**RE: H-20 SWD Site (Redwood Tanks)
Eunice-Monument-Eumont (EME) SWD System
Unit 'H', Sec. 20, T20S, R37E**

RE: **REQUEST FOR APPROVAL TO BACKFILL EXCAVATION**

From: Hansen, Edward J., EMNRD
Sent: Wednesday, October 03, 2007 4:19 PM
To: 'Kristin Pope'; lpg@texerra.com
Cc: Pete Galusky; Price, Wayne, EMNRD
Subject: RE: H-20 Survey with proposed well sites - 1R427-87

**RE: Investigation and Characterization Plan
Rice Operating Company – EME SWD System
H-20 SWD Facilities (UL H Sec 20 T 20S R 37E)**

EXCAVATION CROSS-SECTION: Proposed backfill schematic

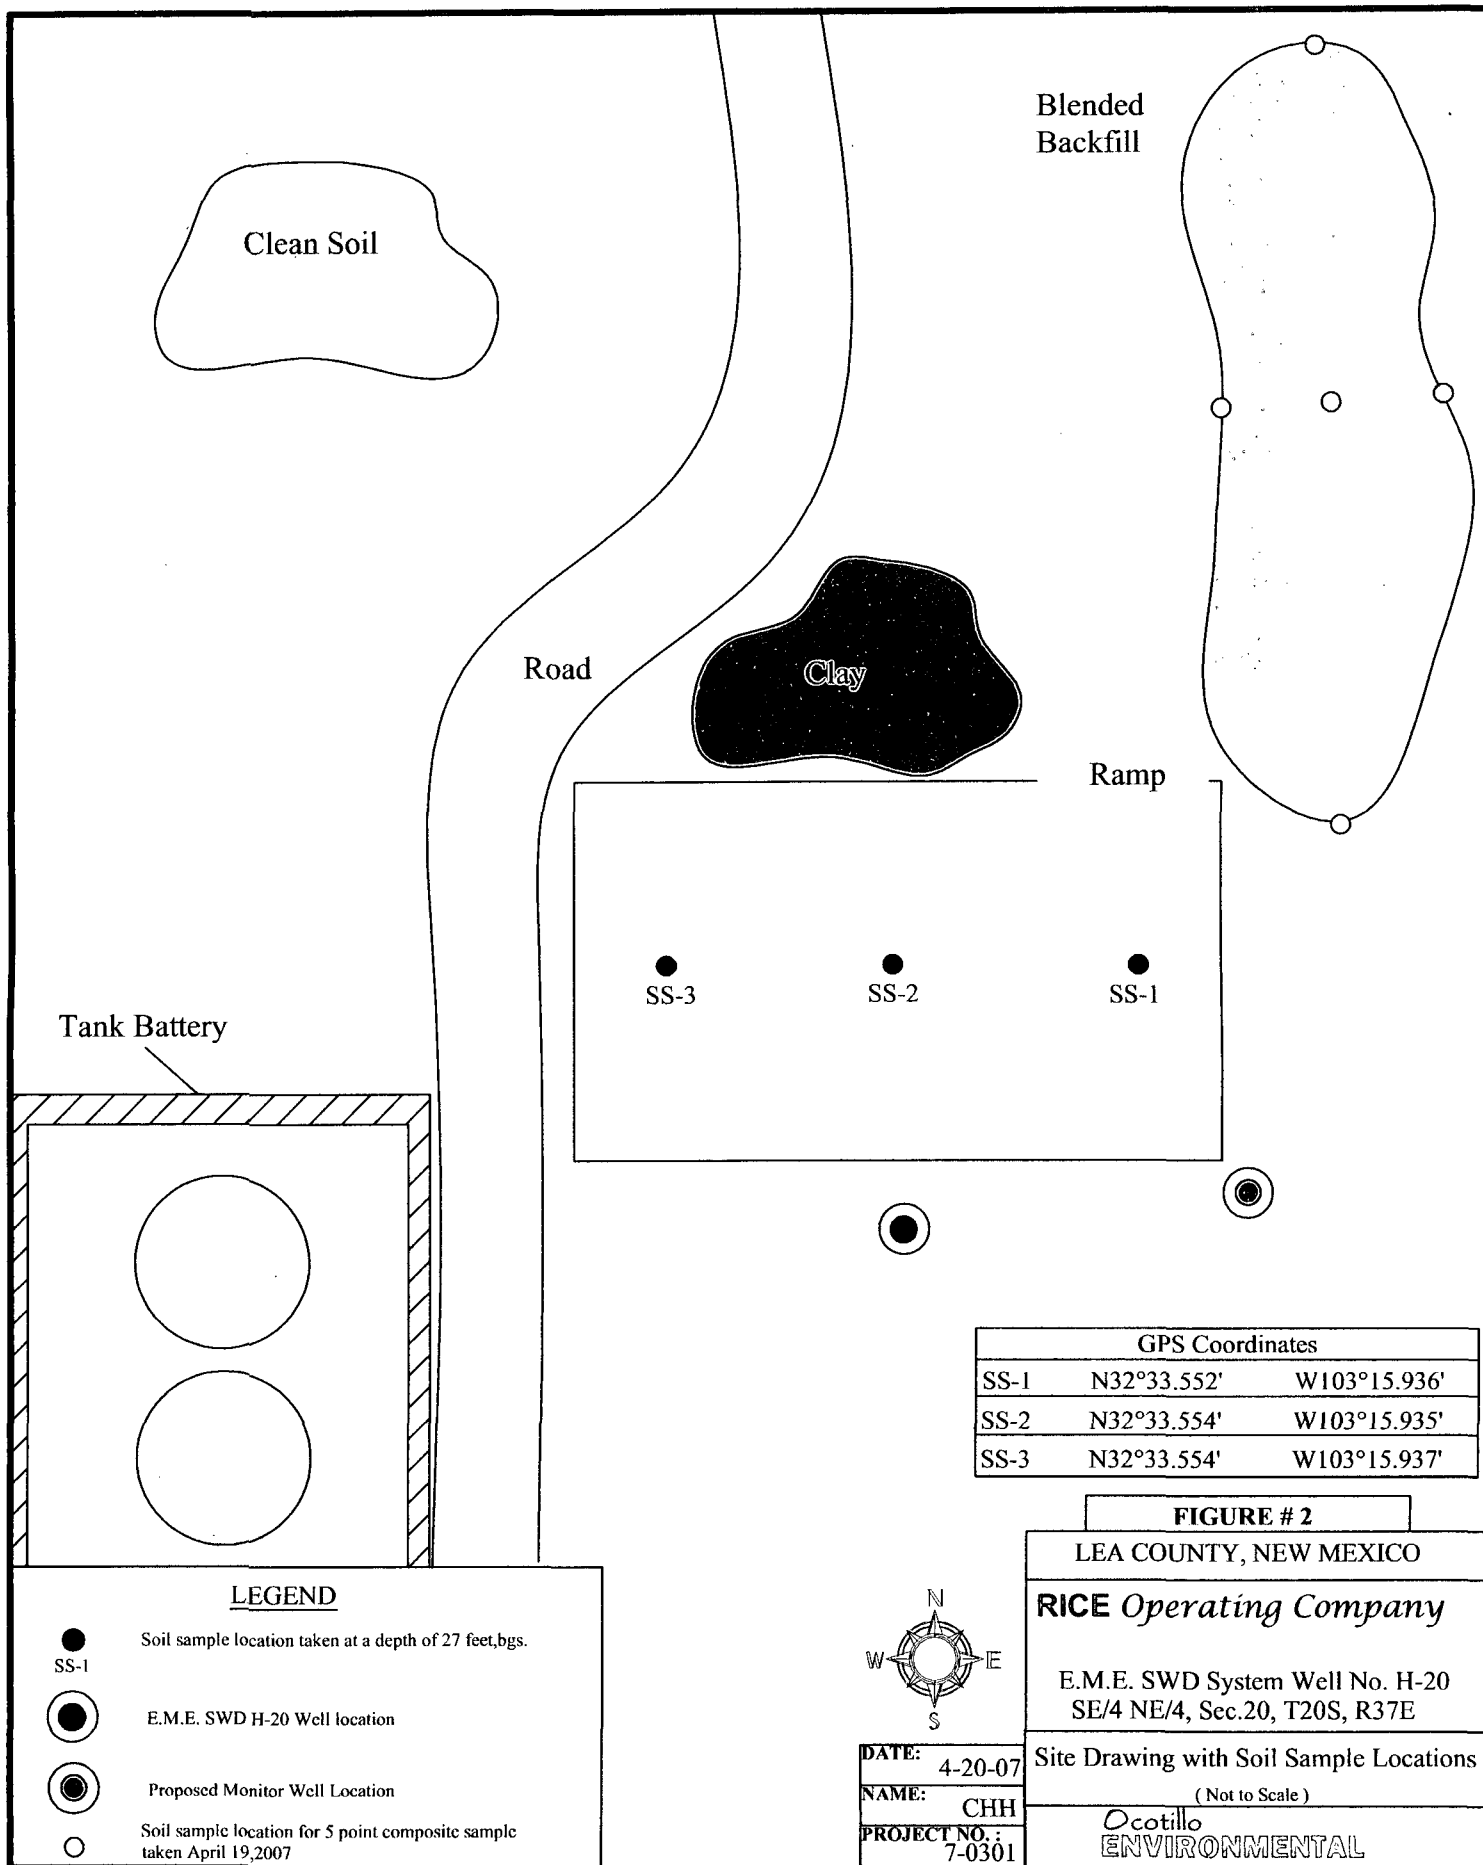
Per the generic work plans, ROC requests permission from OCD to backfill the redwood tank excavation according to the enclosed cross-section schematic. 7 feet of clean sand that was imported from an off-site source has already been placed at the bottom of the excavation to limit exposure of groundwater. Blended backfill with photoionization detection (PID) readings of 26 ppm, 270 mg/kg total petroleum hydrocarbon (TPH), and 160 mg/kg chloride concentrations will be placed on top of the clean sand from 20 to 6 ft below ground surface (BGS). 1.5 feet of clay will be placed at 6 feet BGS and on top of the blended backfill. The Generic Plan calls for a 95% density compaction of clay but recent research shows that compaction to approximately 85% that reflect native, undisturbed soils is more beneficial. **What level of compaction would OCD prefer for this site?** The remaining excavation on top of the clay will be filled with clean, imported topsoil that will sustain native vegetation restoration. A complete excavation report will be submitted to OCD by Ocotillo after the backfill is complete.

- 1) The proposed backfilling shall be initiated by June 1, 2007, at the site.
- 2) The 1 foot clay layer shall be compacted to at least 95% standard Proctor density. The top 6 feet of soil shall be compacted from 80% to 90% standard Proctor density.
- 3) Rice Operating Company must submit a monthly summary report(s) for the site, including a backfilling completion report, a proposal for additional groundwater monitoring wells, analytical results from any samples taken at the site, etc. Upon review of the report(s), the NMOCD will determine if the submittal of an Abatement Plan will be required for the site.

Here are the proposed MW locations we discussed yesterday per the ICP submitted by Pete Galusky. What do you think? We hope for approval of the ICP before drilling on Wednesday. Thanks.

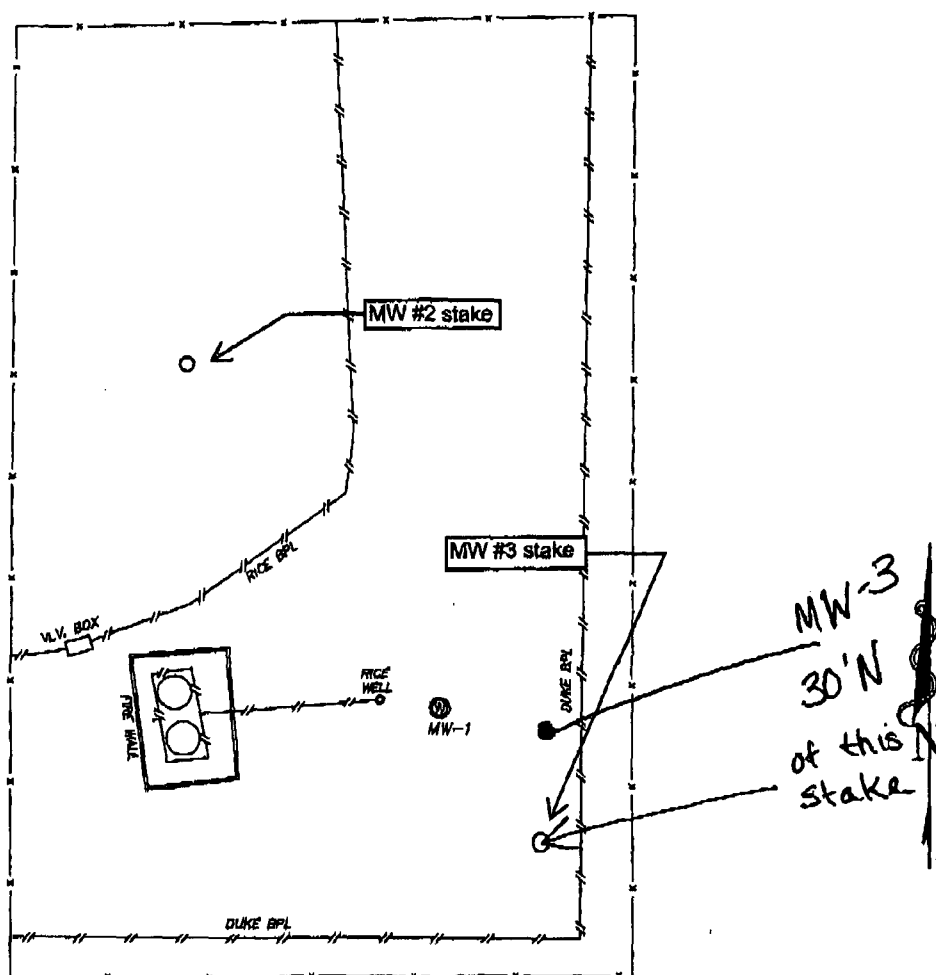
As we discussed today, please only move the proposed location of the downgradient well north by 30 ft. The proposed location of the upgradient well should remain the same.

We could rotate the axis of the line between these wells so that it points more toward the southeast than to the south/southeast, as the locations are presently flagged. Thus, I would move the proposed downgradient well north about 30 ft and the proposed upgradient well south

Also, the groundwater monitoring well, MW-3, should be located to obtain representative samples downgradient of the excavation. Please submit a revised map to reflect the new location of MW-3 prior to installation.

Thank you for faxing the revised site map for the above-referenced site. The proposed locations for the new monitoring wells (the upgradient and the additional downgradient) as indicated on the revised site map are acceptable to the OCD. However, please keep in mind that additional groundwater monitoring wells may be required to delineate the extent of the release.
